UNITED STATES PATENT AND TRADEMARK OFFICE

10/668,659

Office Action Summary	Application No. 10/668,659	Applicant(s) PARK, JOON	
	Examiner Daniel W. Howell	Art Unit 3722

- 1) ☒ Responsive to communication(s) filed on 17 March 2006.
- 2a) ☒ This action is **FINAL**. 2b) ☐ This action is non-final.
- 3) ☐ Since this application is in condition for allowance except for formal matters, prosecution as to the merits is closed in accordance with the practice under *Ex parte Quayle*, 1935 C.D. 11, 453 O.G. 213.

Fig. 1.

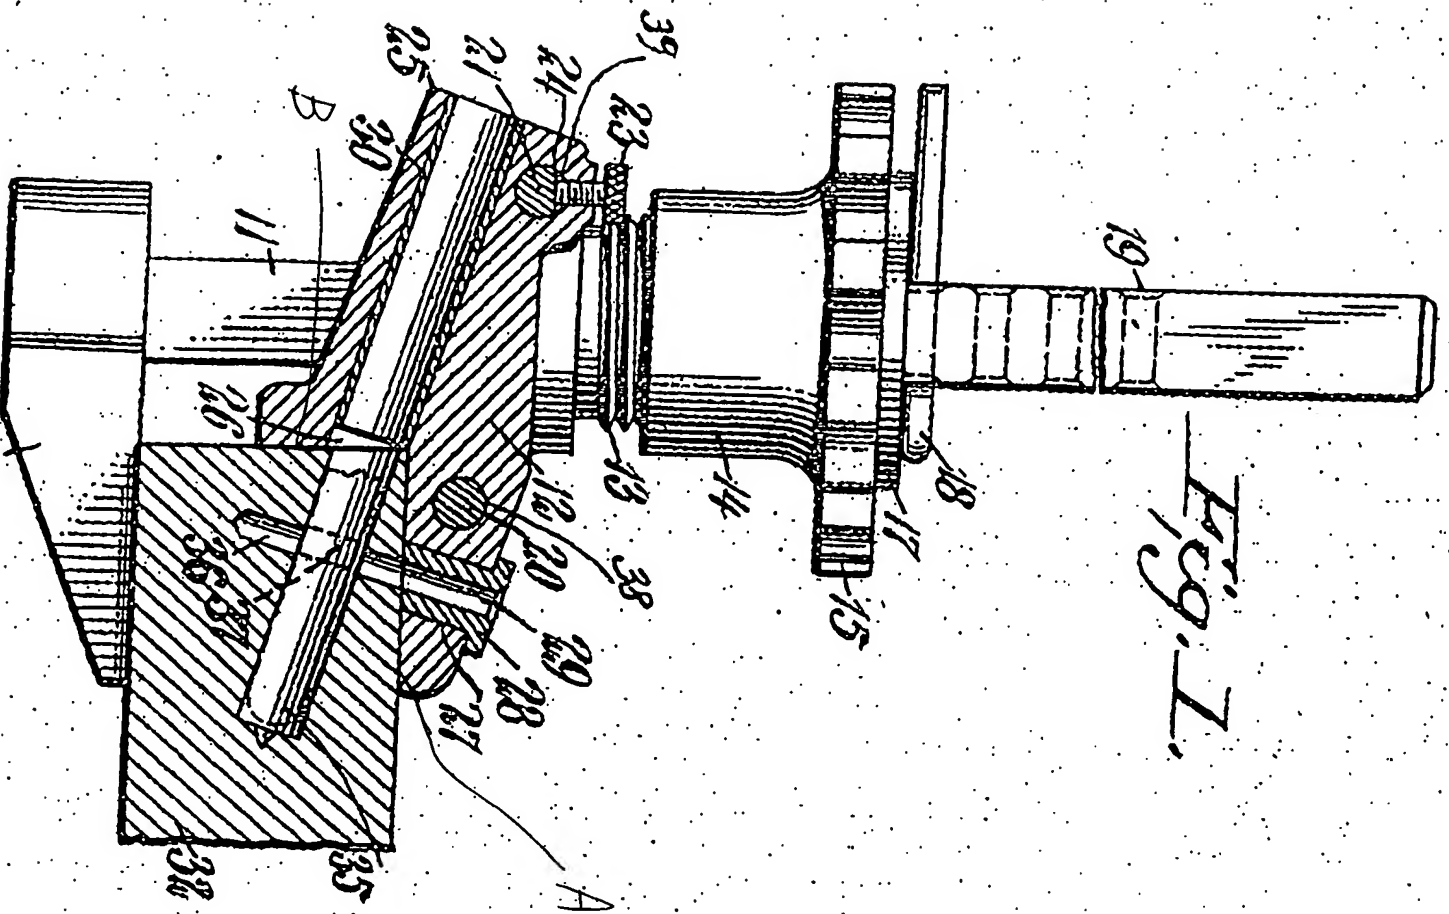
The examiner has attached an enlarged copy of figure 1 of Godefroy et al. The clamp surface adjacent bushing 28 has been labeled “A,” and the clamp surface adjacent bushing 30 has been labeled as “B.” Analyzing claim 1, the guide carrier 22 of Godefroy et al does not move perpendicular to either of surfaces A or B; the guide carrier moves parallel to either of the surfaces. Thus, Godefroy et al does not meet the limitation of line 19 of claim 1.
